HISTORIC LANDMARK COMMISSION
STAFF REPORT

Terrace Falls Sun Deck
PLNHLC2014-00576 & PLNHLC2014-00823
171 East 3rd Avenue
January 15, 2015

West Elevation

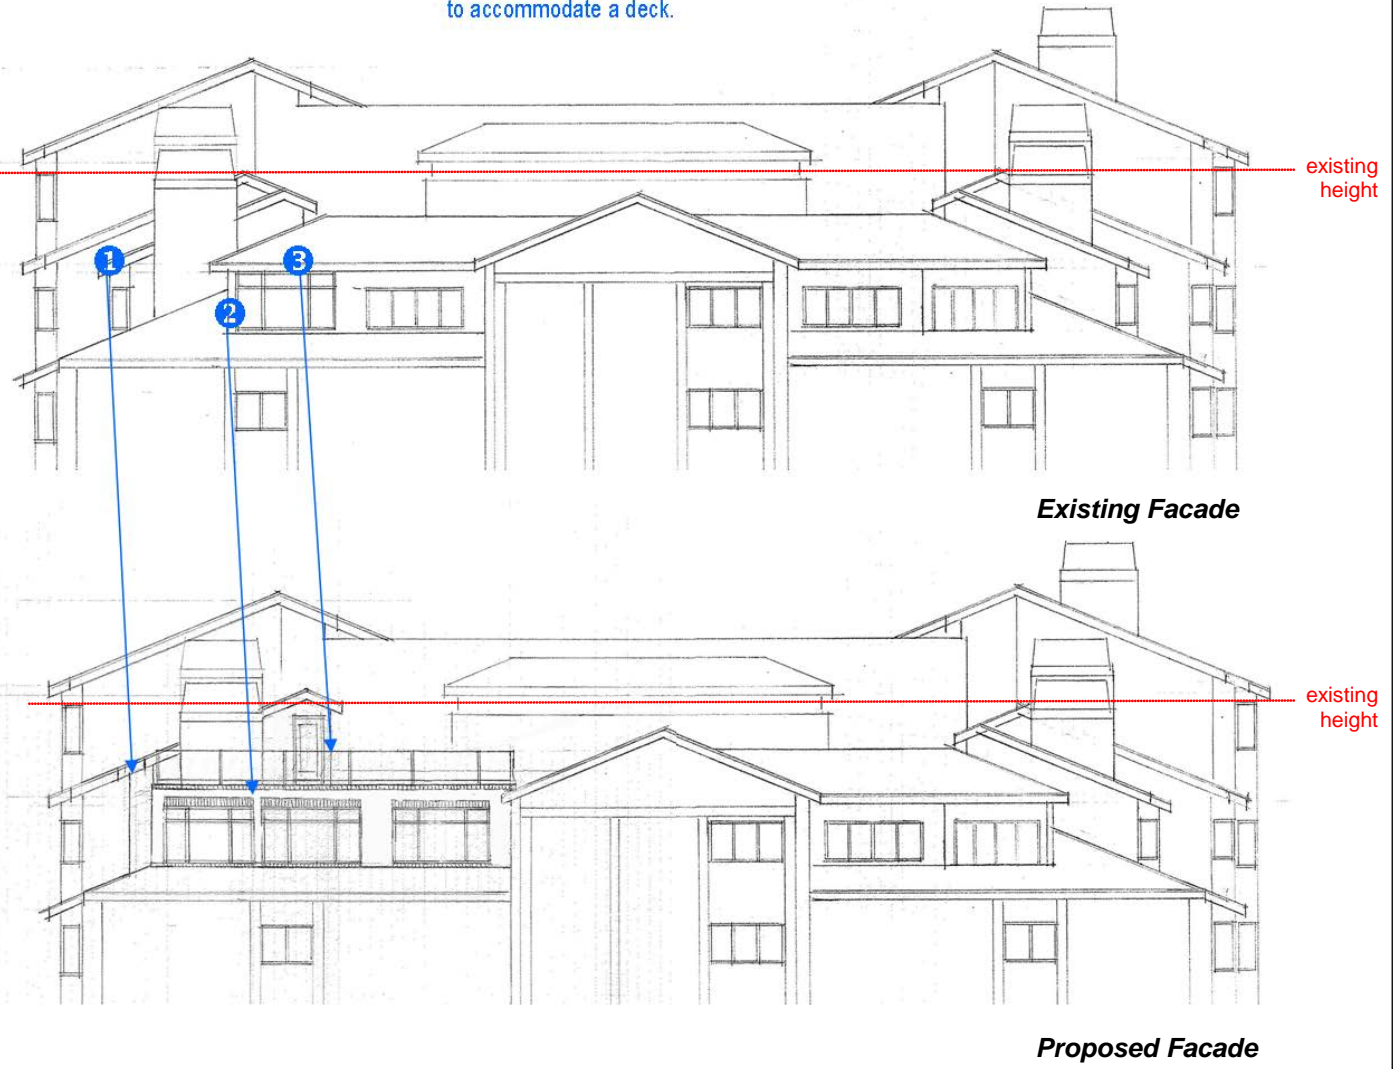
- 1 Extending the northerly sloping roof approximately two feet to create an access to the sun deck.
- 2 Extending the north wall to create additional room on the northwest corner of the building.
- 3 Changing a sloping roof into a flat roof on the west elevation in order to accommodate a deck.

North Elevation - existing

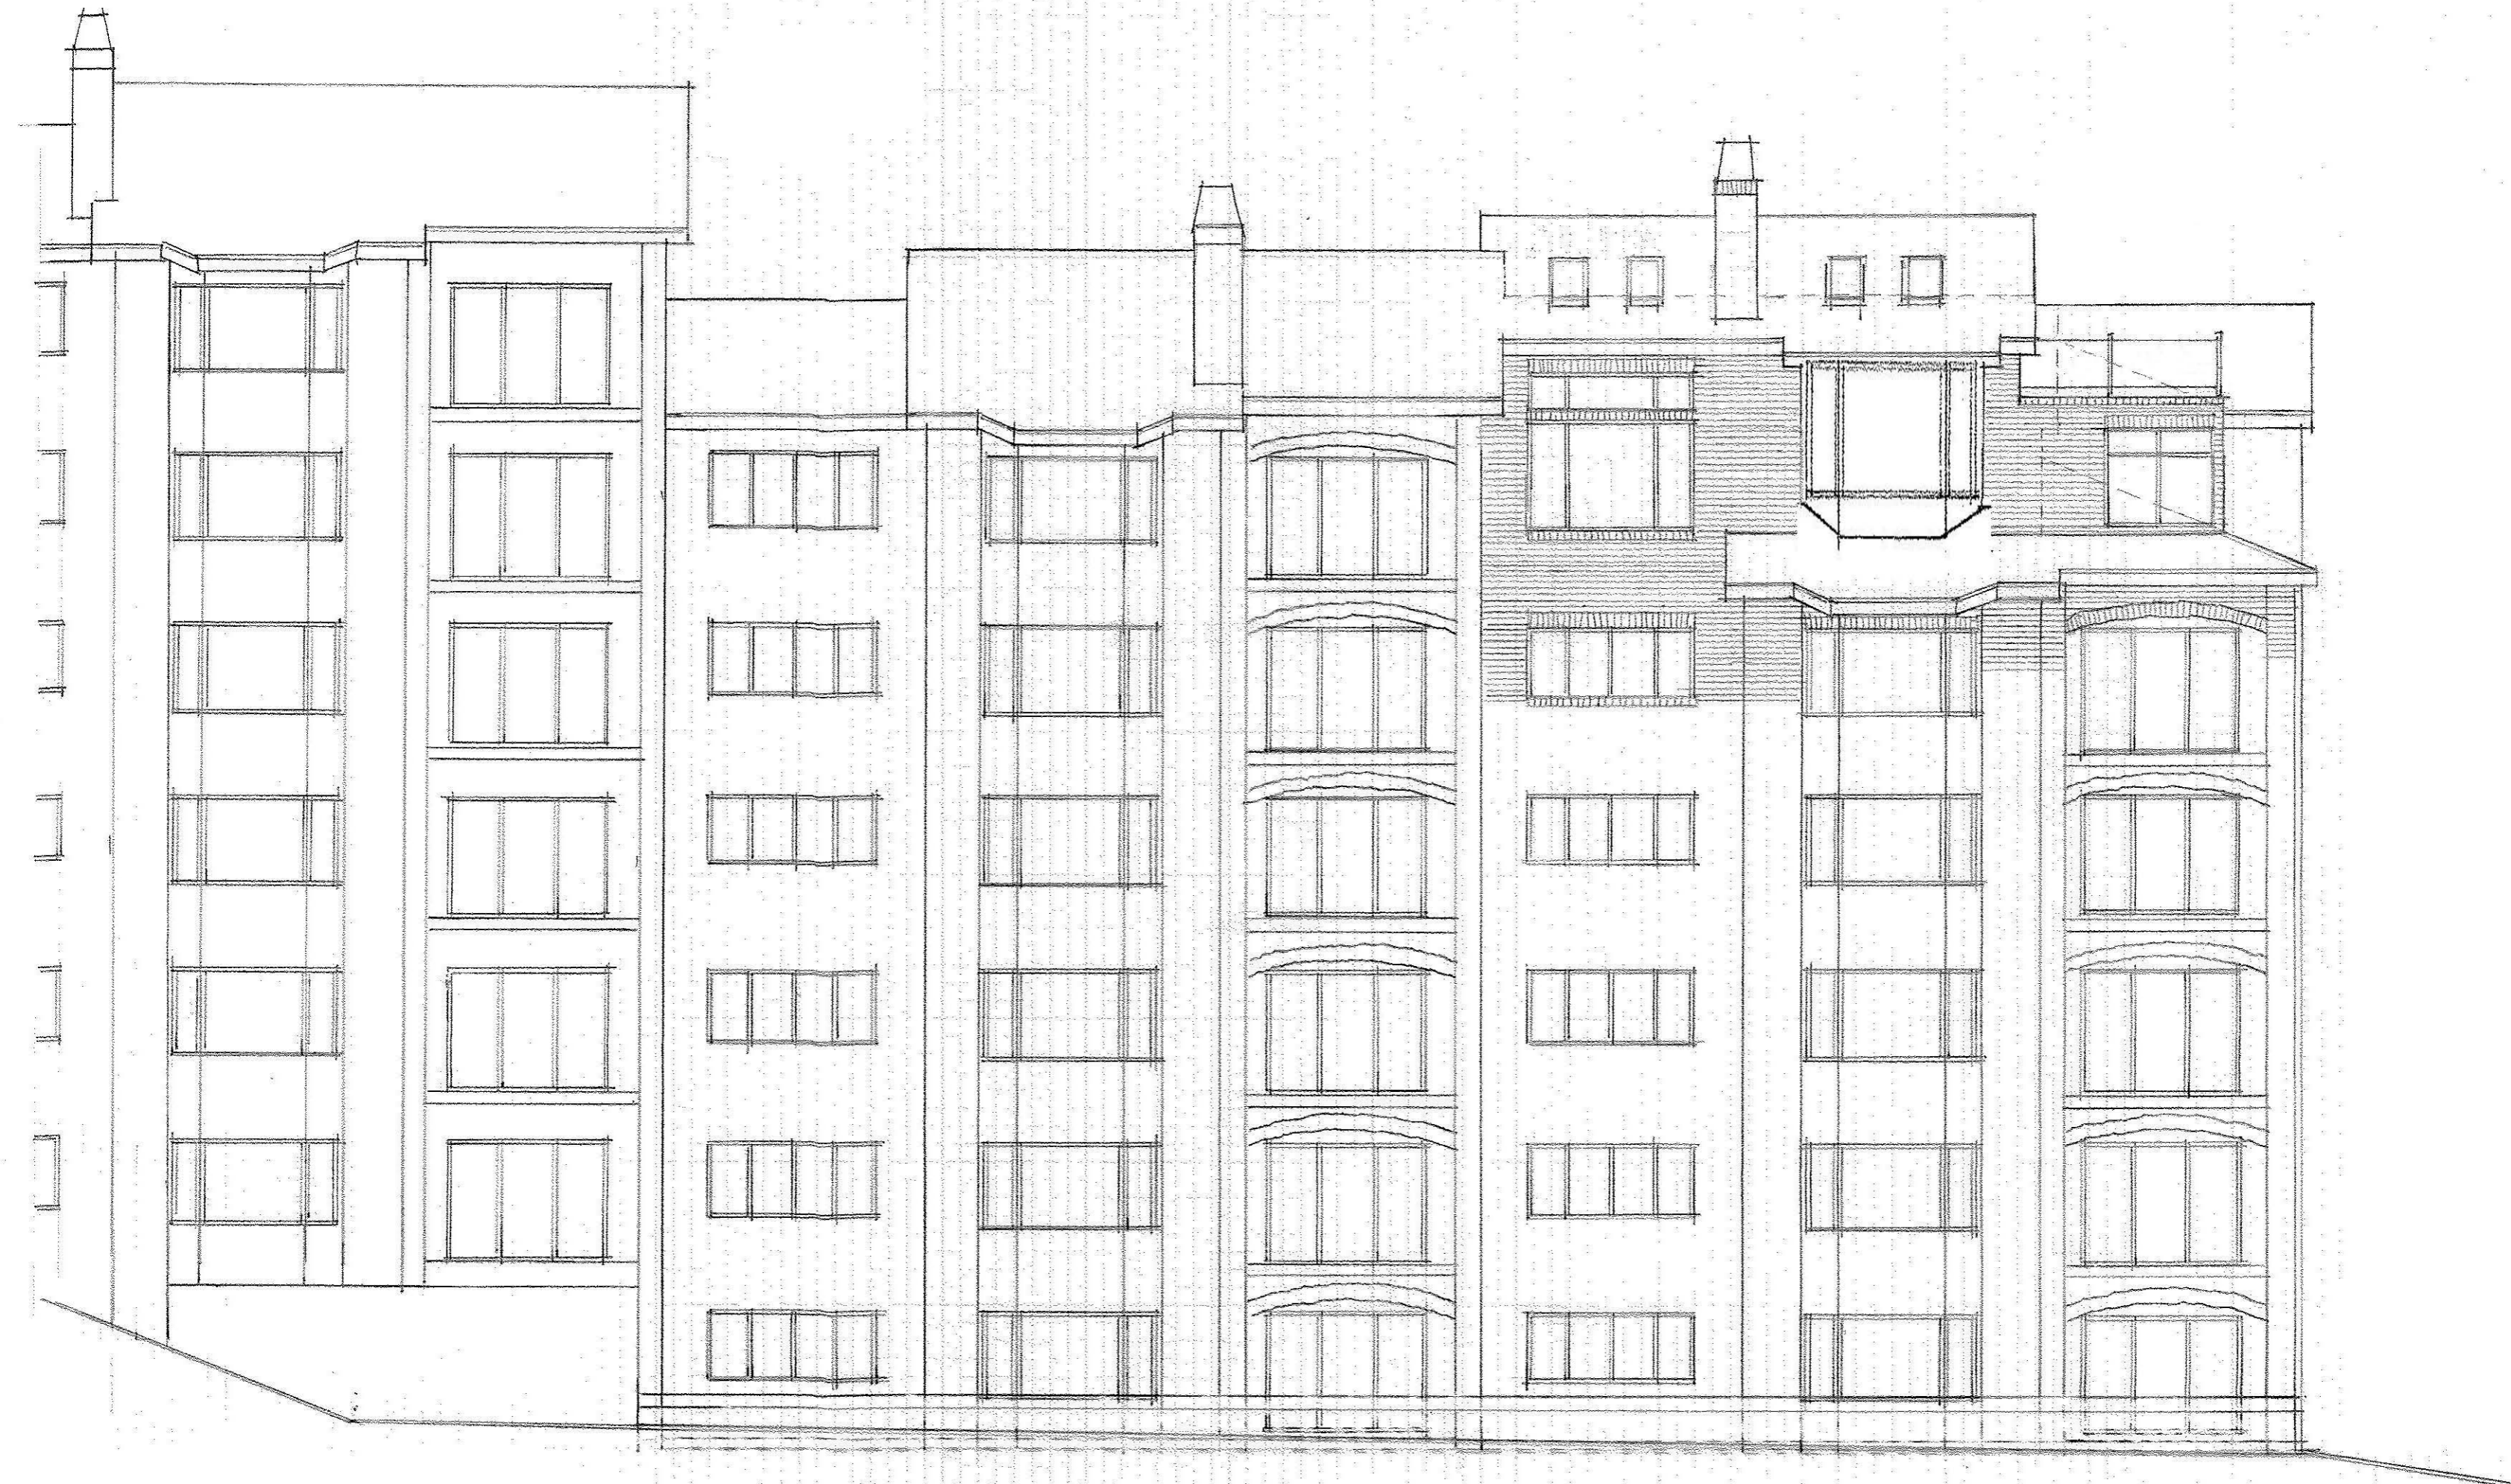
1. Changing a sloping roof into a flat roof on the west elevation in order to accommodate a sun deck.
2. Extending the north wall laterally to create additional room on the northwest corner of the building.
3. Extending the northerly sloping roof approximately four feet (two feet from the overall height of the building) in order to create access to the proposed sun deck.

4. Adding new windows on the wall under the deck.
5. Adding a new door to the deck.
6. Adding new wrought iron railing.
7. Extending the windows on the north elevation.
8. Adding new skylights on the north roof.
